#### **Service Provider Letter**

CWS File Number	
25-00	0377

Jurisdiction:	City of Tualatin	Review Type:	Tier 2 Ana	alysis
Site Address / Location:	18870 SW 128th Ave Tualatin, OR 97062	SPL Issue Date SPL Expiration		
Applicant Infor	mation:	Owner Informa	ation:	
Name		Name	HALEY GRIMM	
Company	AKS ENGINEERING & FORESTRY, LLC	Company	GRIMM'S FUEL CO	
Address	12695 SW HERMAN RD, SUITE 100	Address	18850 SW CIPOLE R	D
	TUALATIN, OR, 97062		TUALATIN OR 97062	
Phone/Fax	(503) 563-6151	Phone/Fax	(503) 636-3233	
E-mail:	schillingr@aks-eng.com	E-mail:	haleygrimmgfc@gmai	l.com
2S121A002 <sup>2</sup>	Tax lot ID	Gra	Development Active Vel Improvement & Storm	-
Pre-Development Site Conditions:  Sensitive Area Present: X On-Site X Off-Site  Vegetated Corridor Width: Variable  Good/Marginal/Degraded  Vegetated Corridor Condition:		Post Development Site Conditions:  Sensitive Area Present: X On-Site X Off-Site  Vegetated Corridor Width: Variable		
Enhancement of Remaining Vegetated Corridor Required:		Square Foota	ge to be enhanced:	64,701

This Service Provider Letter is not valid unless CWS-approved site plan is attached.

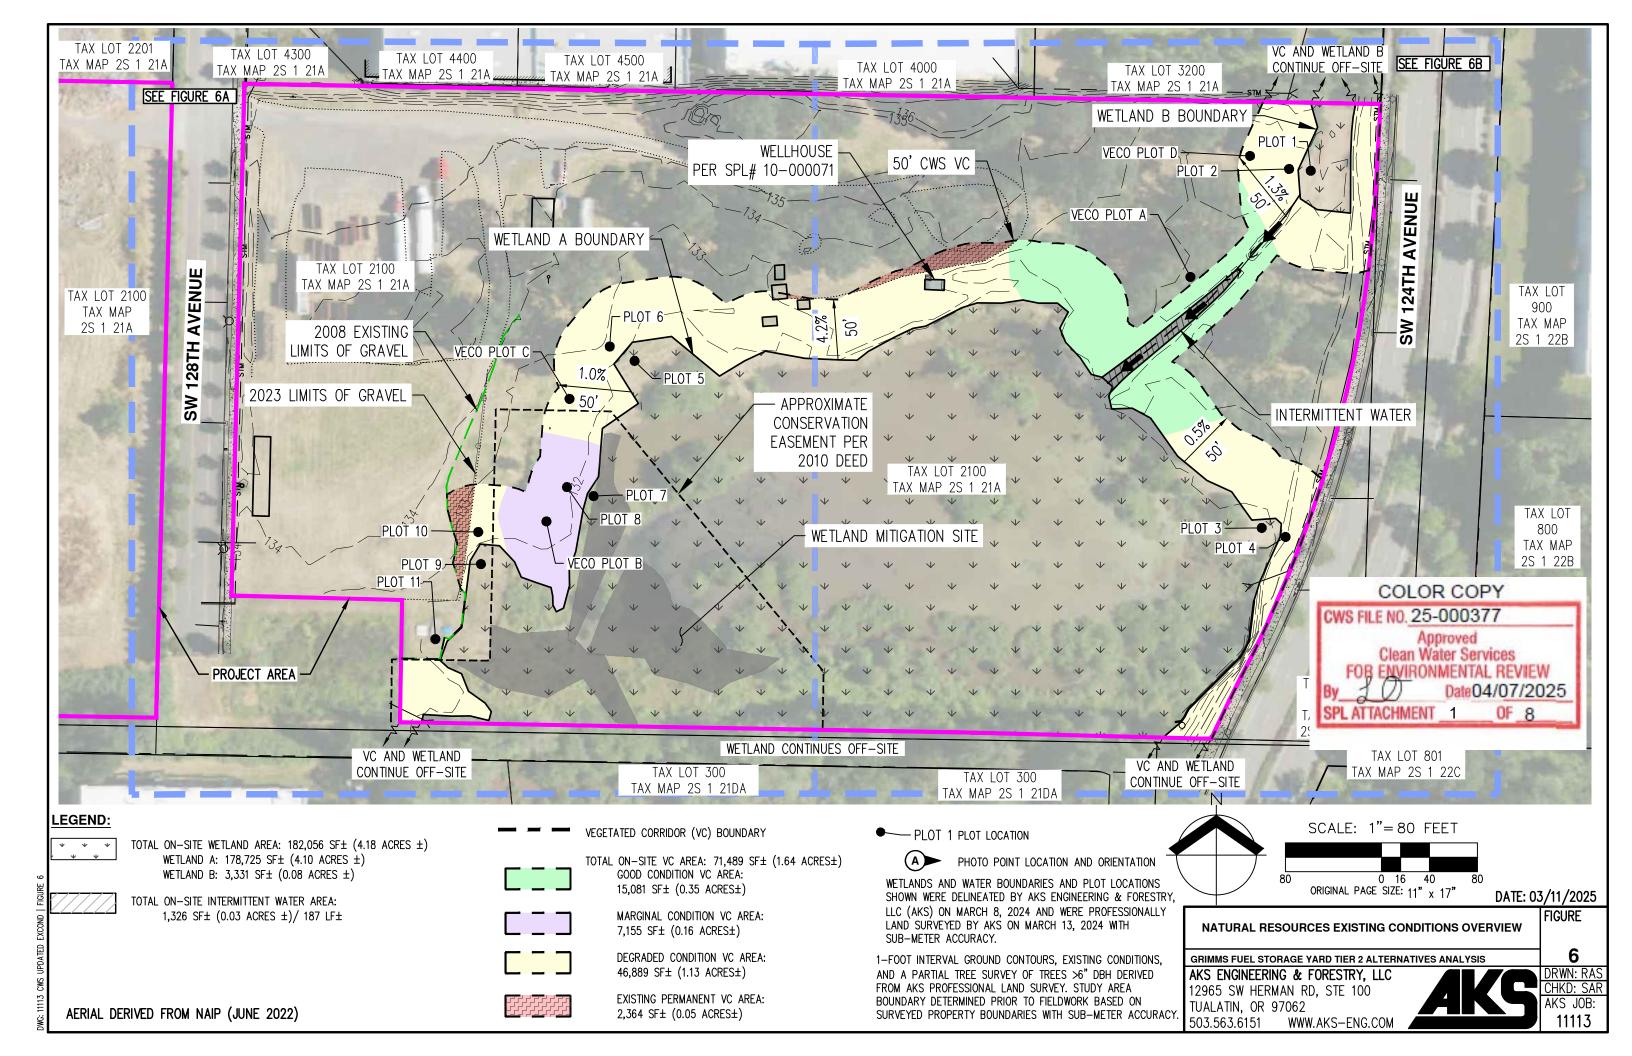
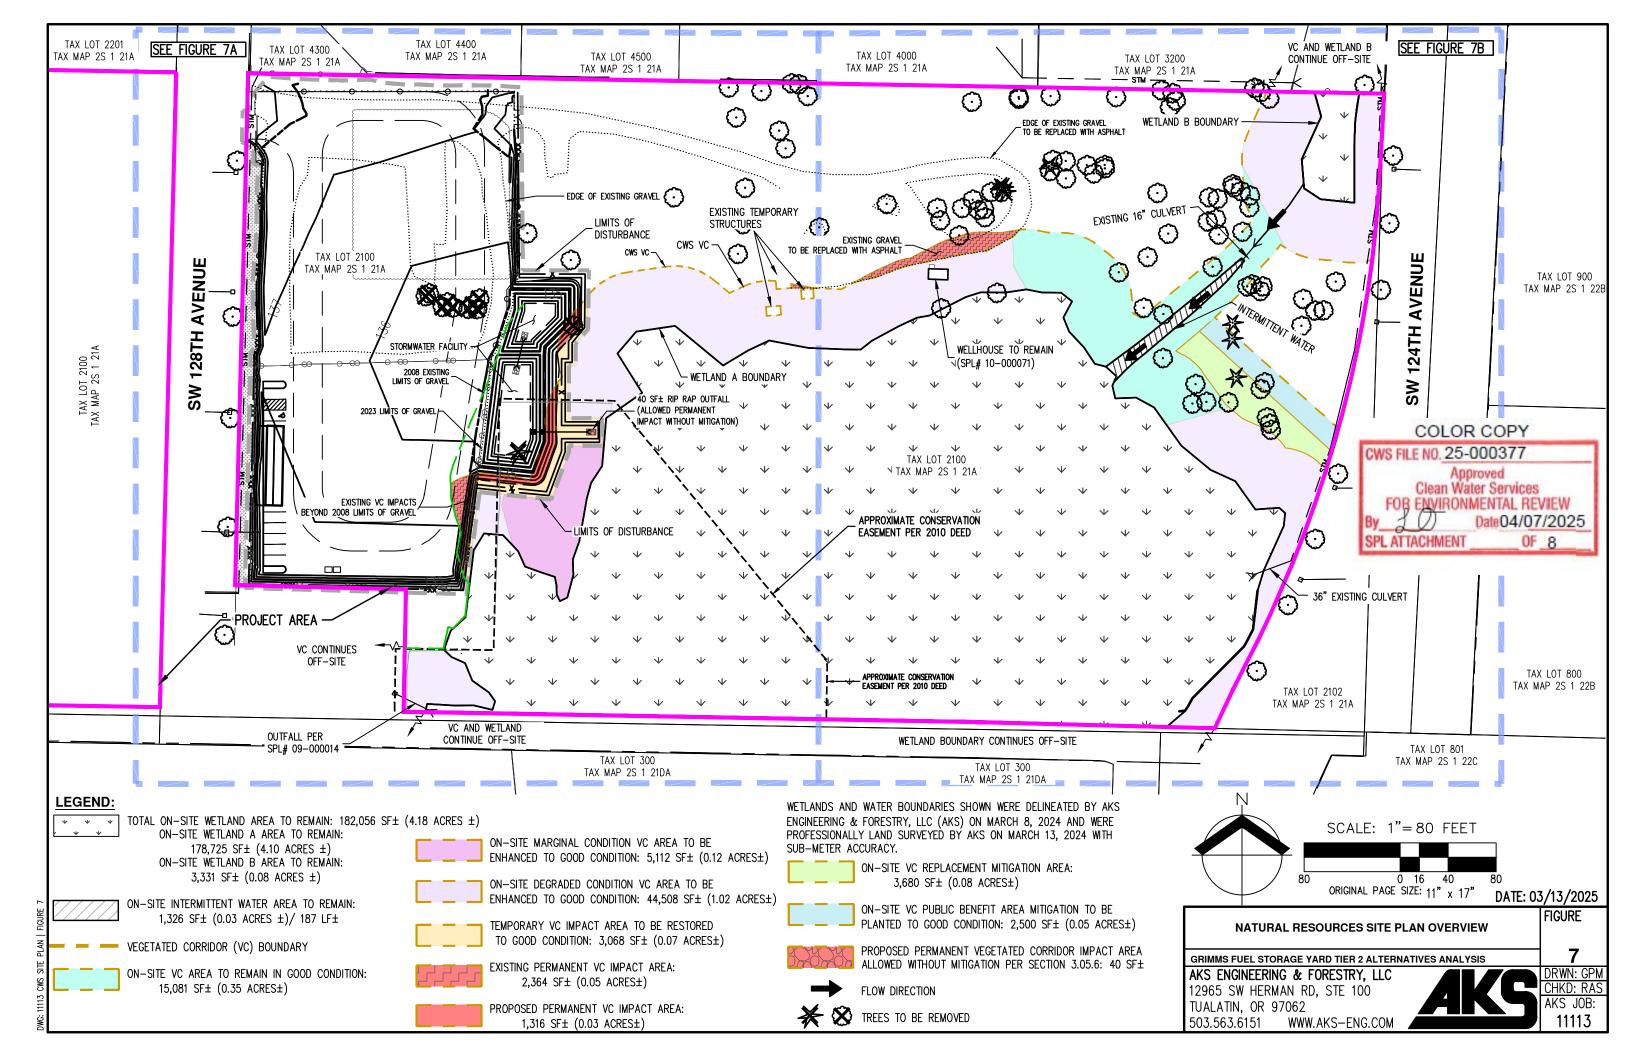
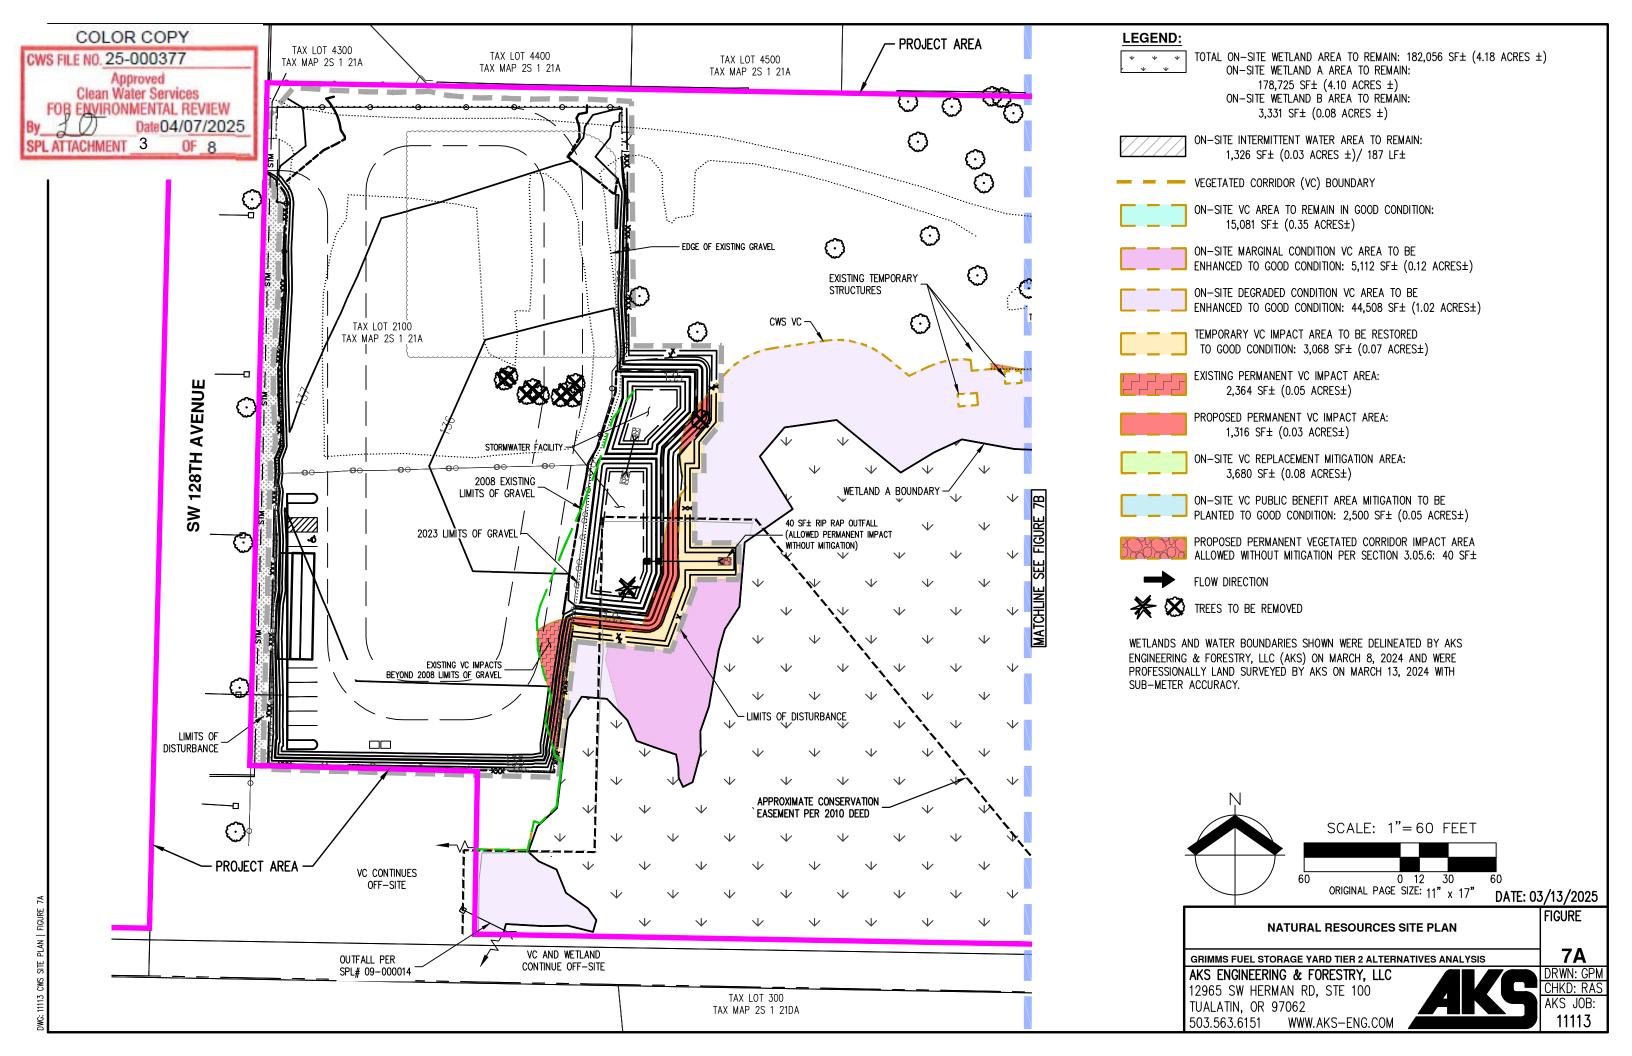
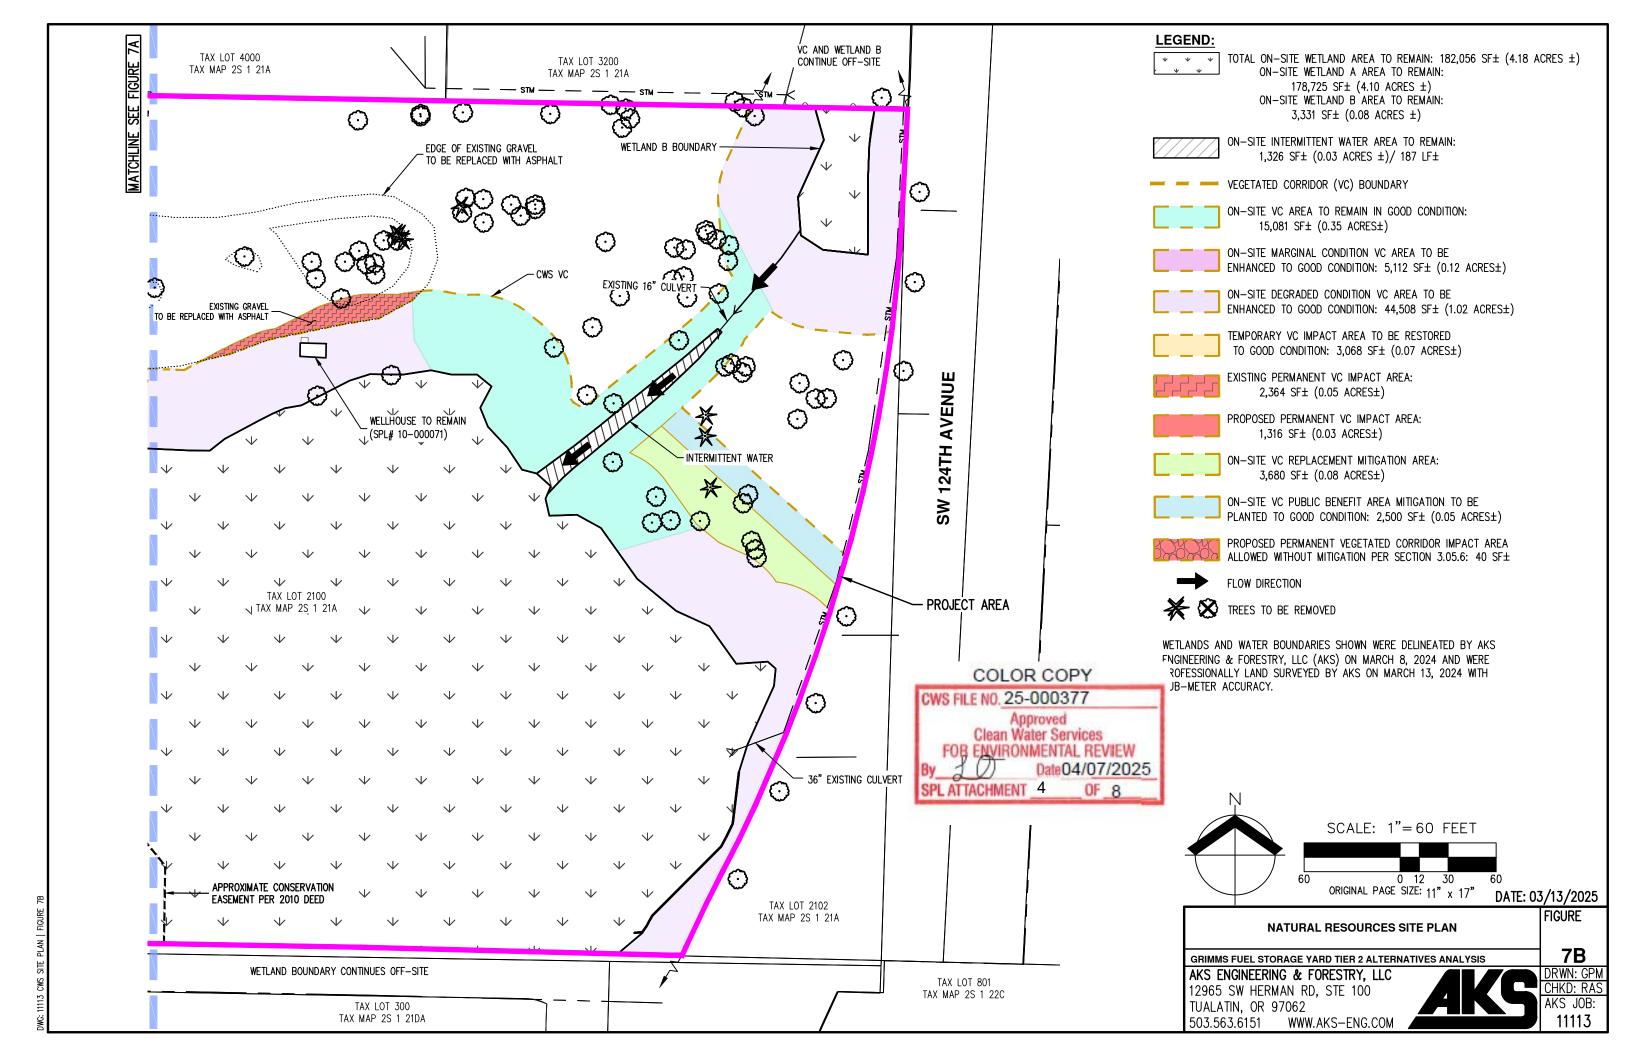
Encroachments into Pre-Development Vegetated Corridor:				
Type and location of Encroachment:  Gravel parking lot expansion & stormwater facility (Permanent encroachment; Mitigation required)  Rip rap outfall (Permanent encroachment; No mitigation required under 100 SF)  Construction of stormwater facility (Temporary encroachment; Restoration and planting in-place)				Square Footage: 3,680 40 3,068
	Mitigation R	equirements:		
	ment Mitigation as Public Benefit			Sq. Ft./Ratio/Cost 3,680 2,500
X Conditions	Attached   X   Development Figures Attached	(4) X Planting F	Plan Attached   Geot	ech Report Required

- 10. Should final development plans differ significantly from those submitted for review by Clean Water Services, the applicant shall provide updated drawings, and if necessary, obtain a revised Service Provider Letter.

- 11. The Vegetated Corridor width for sensitive areas within the project site shall be a minimum of 15 feet wide, as measured horizontally from the delineated boundary of the sensitive area.

- 12. For Vegetated Corridors up to 50 feet wide, the applicant shall enhance the entire Vegetated Corridor to meet or exceed good corridor condition as defined in R&O 19-5, Section 3.14.2, Table 3-3, as amended by R&O 19-22.

# PRELIMINARY SITE AND STORMWATER PLAN TOWING YARD IMPROVEMENTS GRIMM'S FUEL COMPANY TUALATAN, OREGON PRELIMINATE PRELIMINATION CONSTRUCTION

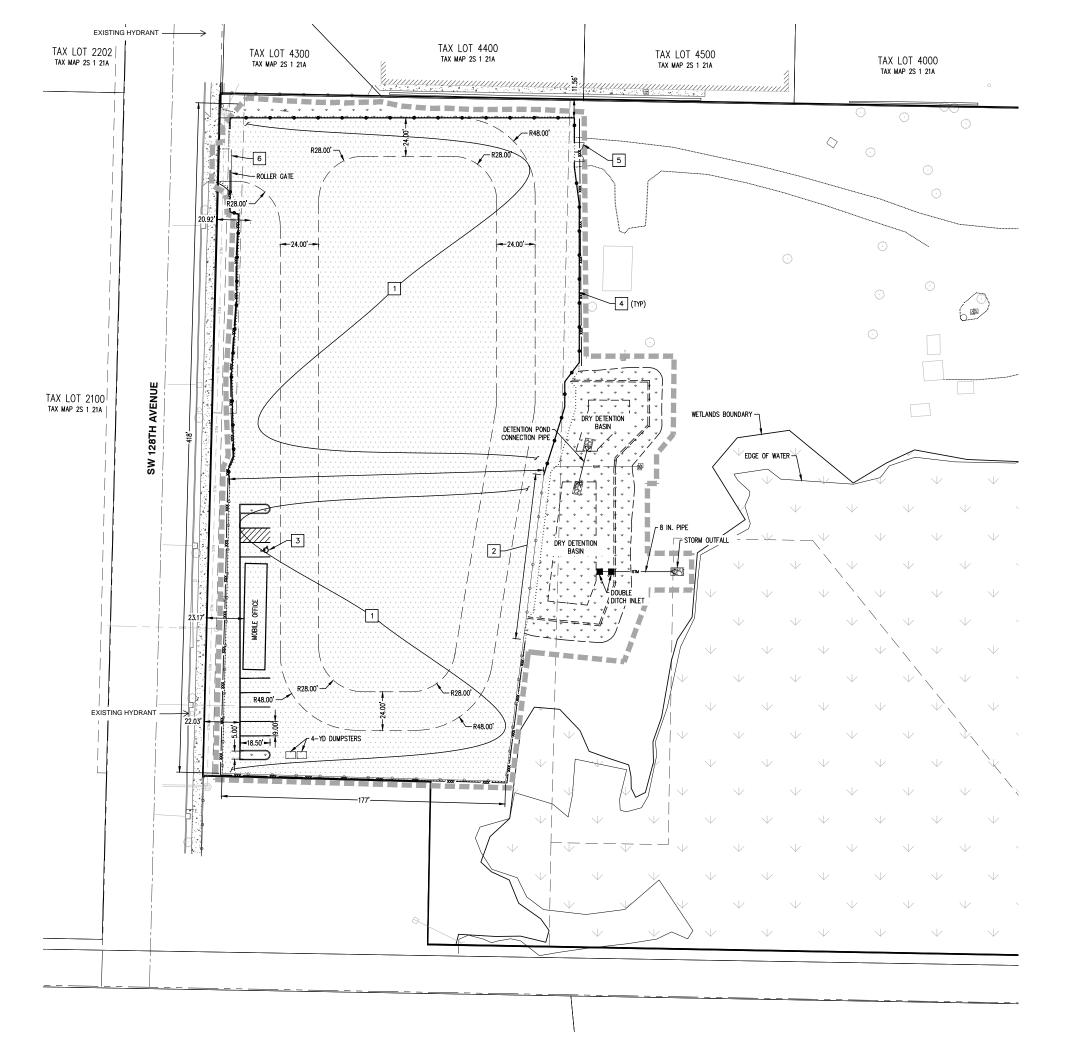
# This section is for application approval only Fire Marshal or Designee Conditions: The Structures or impacts to Fire department access/water Supply, See Attached Conditions: ☐ Yes No Site Inspection Required: ☐ Yes 🗡 No
